Access Compliance Report

Public Rights-of-Way

Intersection ID: 46949	Main Street: PROVIDENCE_LN_WEST	Cross Street: MADISON_OAKS_CT	Location: S
ADA ID: 45505A0D912B	Ramp Type: PerpDiag	Initial Pass/Fail: Fail	Overall Compliance: No
Severity Score: 25			
Codes/Mitigation Info/Possible Solution		Field Measurements/Component Compliance

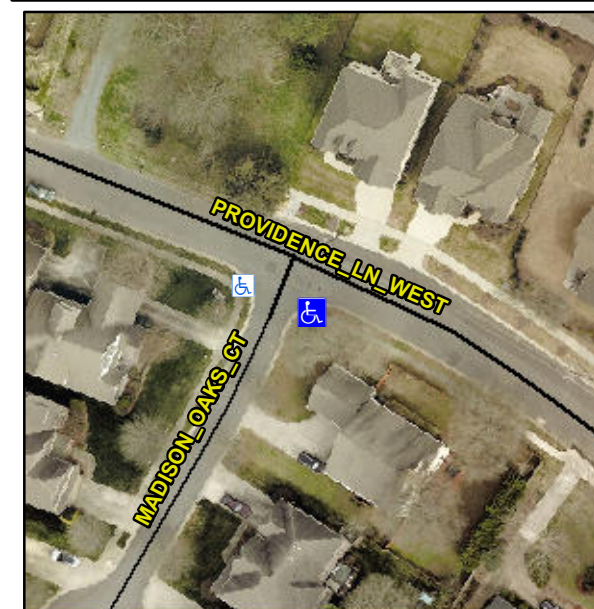
Not Found, R304.5.3

Compliance	Description	Data	Compliance	Description	Data
N/A	Ramp Length (in)	96.0	Yes	Ramp Slope (%)	5.4
Yes	Ramp Width (in)	48.0	No	Ramp XSlope (%)	13.9
N/A	Flare Type LT	N/A	N/A	Flare Type RT	N/A
N/A	Flare Slope LT (%)	N/A	N/A	Flare Slope RT (%)	N/A
N/A	Flare Traversable LT?	N/A	N/A	Flare Traversable RT?	N/A
N/A	Landing Length (in)	N/A	N/A	DWS Provided?	N/A
N/A	Landing Width (in)	N/A	N/A	DWS Contrast?	N/A
N/A	Landing Slope (%)	N/A	N/A	DWS Length (in)	N/A
N/A	Landing X Slope (%)	N/A	N/A	DWS Full Width?	N/A
N/A	Landing Curb? (Y/N)	N/A	N/A	DWS Offset (in)	N/A
N/A	Shared Landing?	N/A			
N/A	Gutter Ponding?	N/A	N/A	Gutter Slope (%)	N/A
N/A	Gutter Lip Ht (in)	N/A	N/A	Gutter X Slope (%)	N/A
N/A	Painted X Walk1?	No	N/A	Painted X Walk2?	No
	X Walk 1 Direction	To NE		X Walk 2 Direction	To NW
N/A	X Walk 1 Width (in)	N/A	N/A	X Walk 2 Width (in)	N/A
	X Walk 1 Slope (%)	10.2		X Walk 2 Slope (%)	3.8
	X Walk 1 X Slope (%)	5.9		X Walk 2 X Slope (%)	8.2

Remove & Replace Curb Ramp With Two New Directional Ramps or Equivalent.
